SCSI-3 CONNECTOR

CLAUDE MOSLEY

IBM ROCHESTER, MN

WORKING MEETING

PIN EXAMAPLES

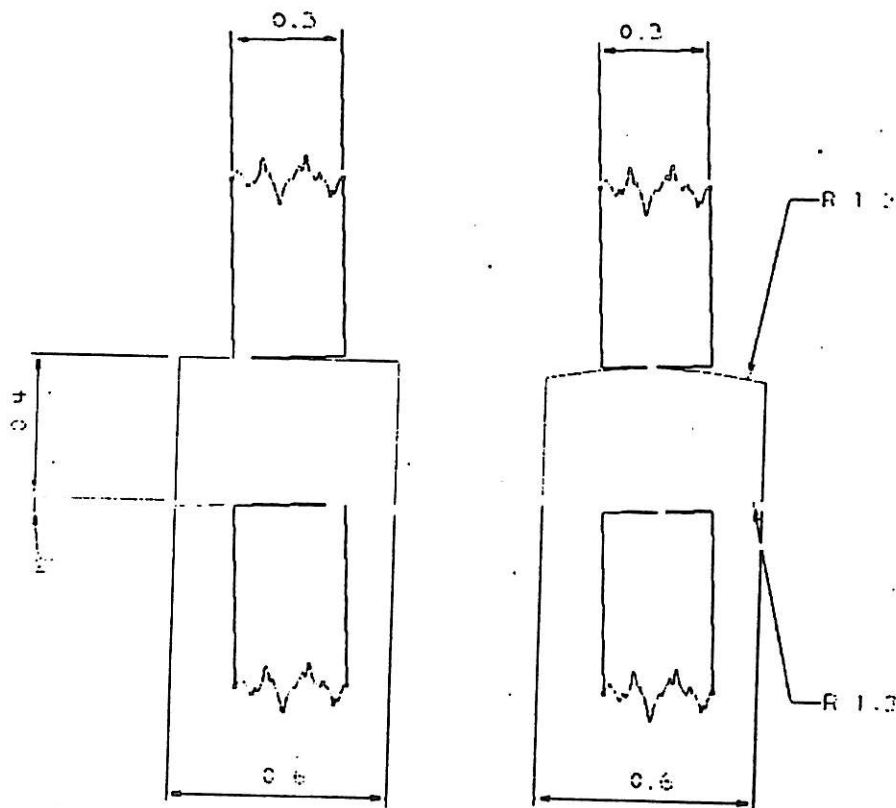
- **PIN -- .016 X .024 ON .050 CENTERS**

- **MATING SURFACE TO HAVE A RADIUS OF 1,25 MAX**

- **SURFACE FINISH TO N5 (RA OF 0,0004mm or 16uin.) OR BETTER**

- **PLATING ON THE ENTIRE MATING SURFACE TO BE A MINIMUM OF 0,000762(30uin) GOLD OVER 0,00127(50uin) NICKEL**
